Technical Service Bulletin

30 Clutch pedal makes noises when pressed

30 13 17 2032224/2 January 8, 2013. Supersedes Technical Service Bulletin Group 30 number 12-16 dated December 21, 2012 for reasons listed below.

Model(s)	Year	VIN Range	Vehicle-Specific Equipment
TT	2012-13	All	Manual transmission
A3

Figure 3. Mounting held together before installing felt.

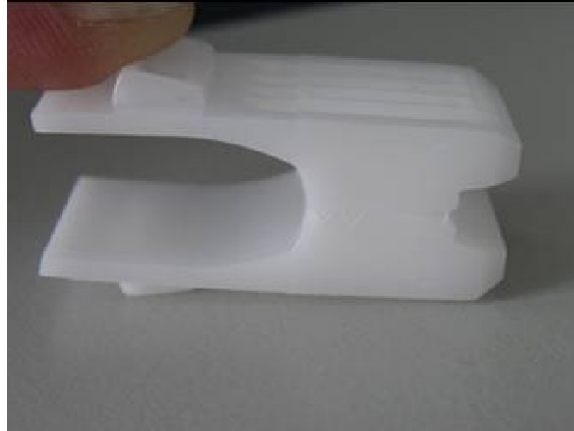
Excess clearance between mounting of clutch master cylinder and pedal assembly.

4. While holding the mounting (part number: **1K0 721 357 A**) closed (Figure 3), install felt strip onto both sides of mounting.

Replace mounting on clutch pedal and attach felt pieces on mounting to remove clearance.
